DATE: December 16, 2019

SUBJECT: ADDENDUM #4 TO THE BIDDING DOCUMENTS FOR:  
**BID GROUP #8**  
**MASTER FACILITY PLAN IMPLEMENTATION**  
**COMMUNITY HIGH SCHOOL DISTRICT 99**  
**1436 NORFOLK STREET**  
**DOWNERS GROVE, IL 60516**

This addendum forms a part of the Bidding Contract Documents, dated November 20, 2019. Bidders must acknowledge receipt of this Addendum in the space provided on the Bid Form. Drawing revisions clouded and tagged throughout with delta 41.

10 FRAMING DETAIL  
SCALE: 3/4" = 1'-0"

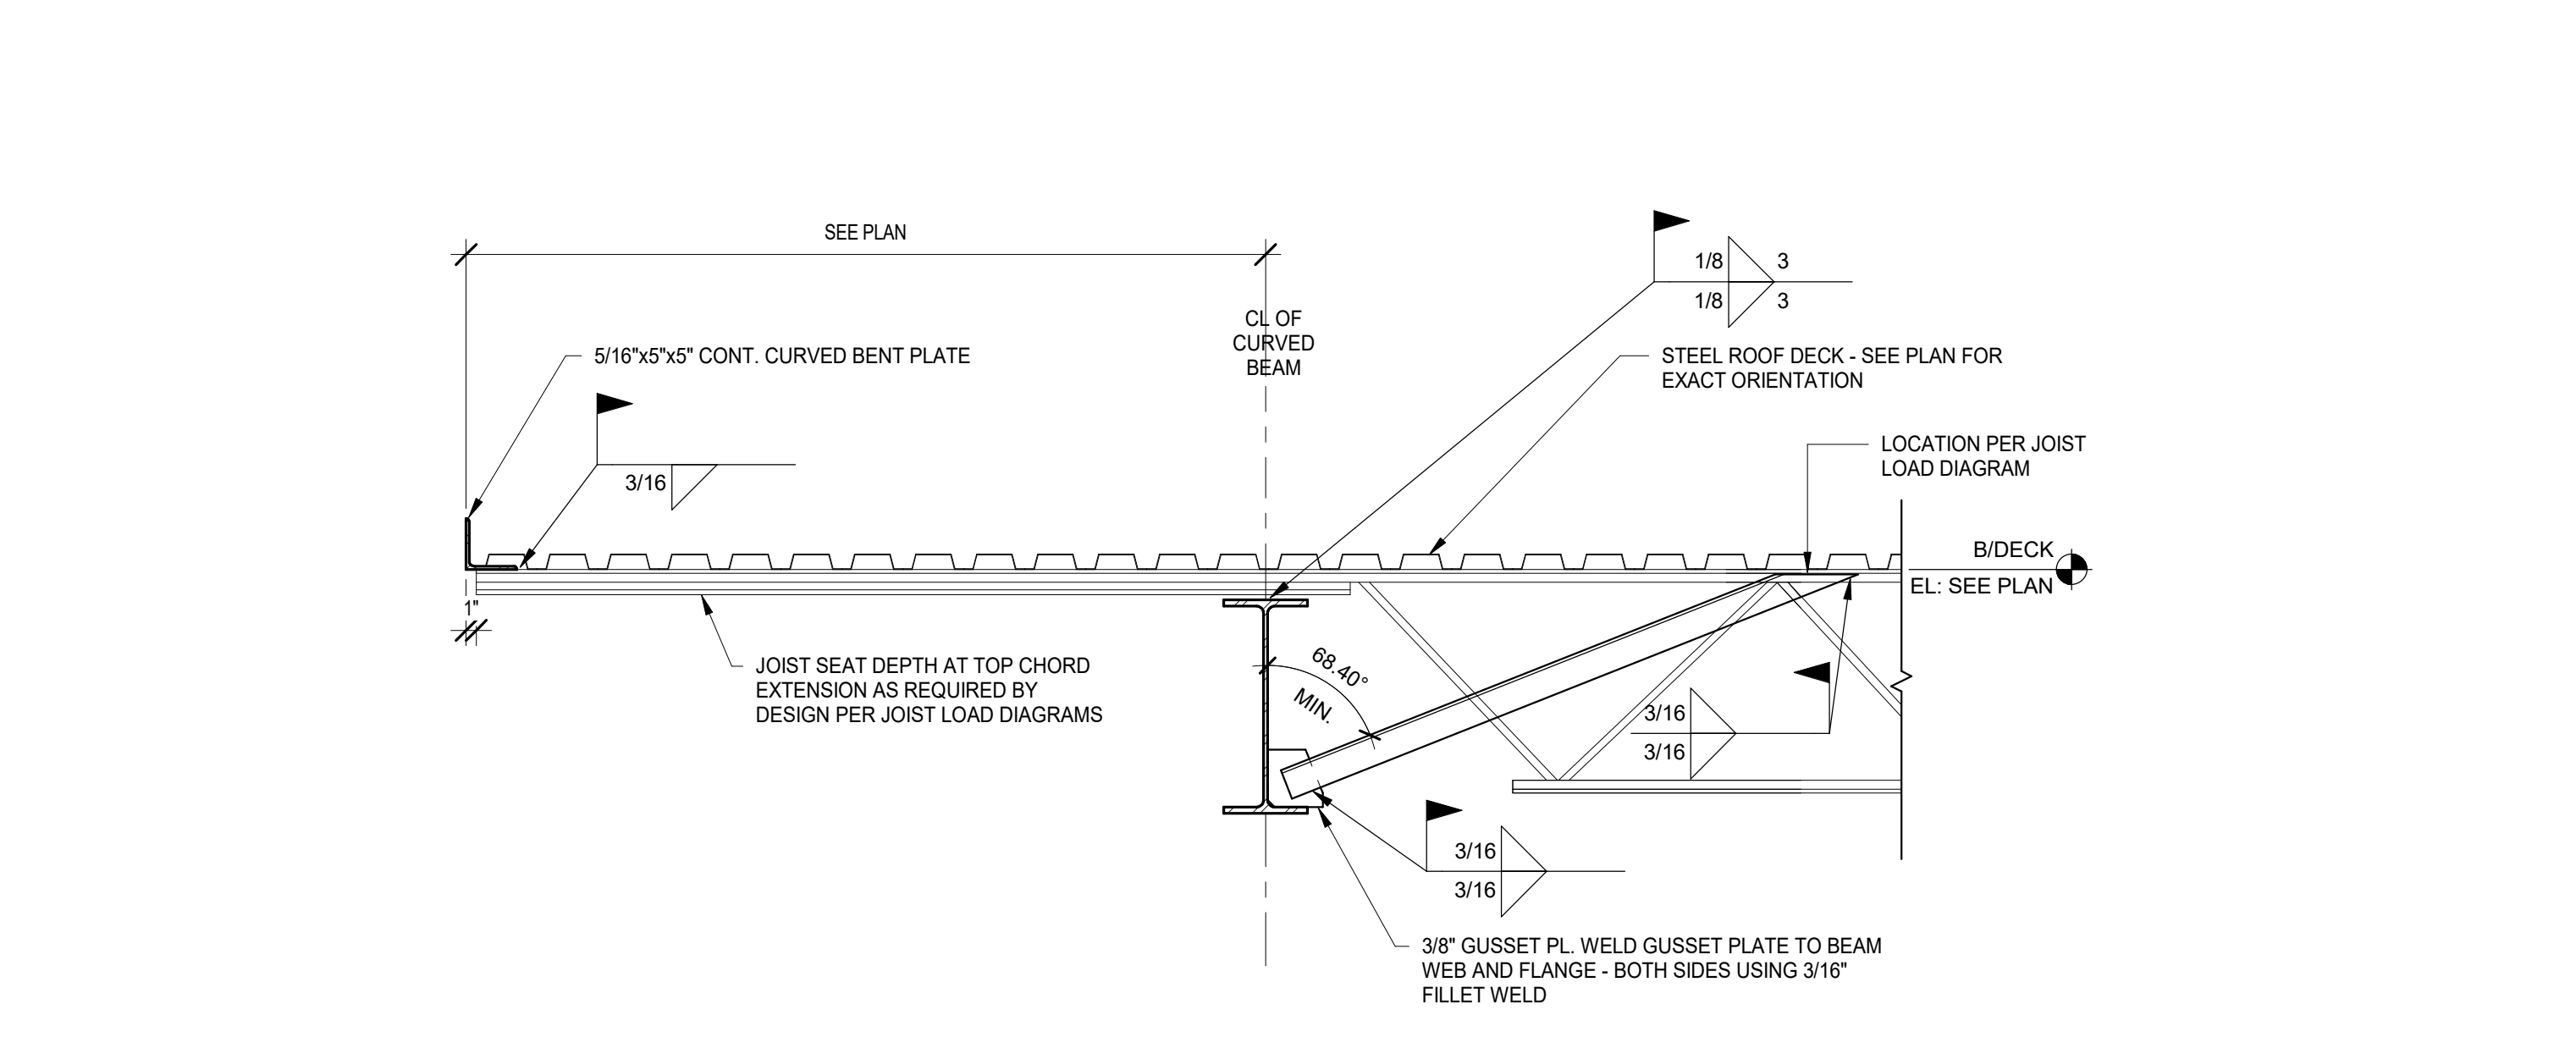
13. Sheet S3.6C-F NON-TYPICAL SECTIONS AND DETAILS (**Full size sheet issued**)
  - a. Revised details 2 and 10.
14. Sheet S3.7C-F NON-TYPICAL SECTIONS AND DETAILS (**Full size sheet issued**)
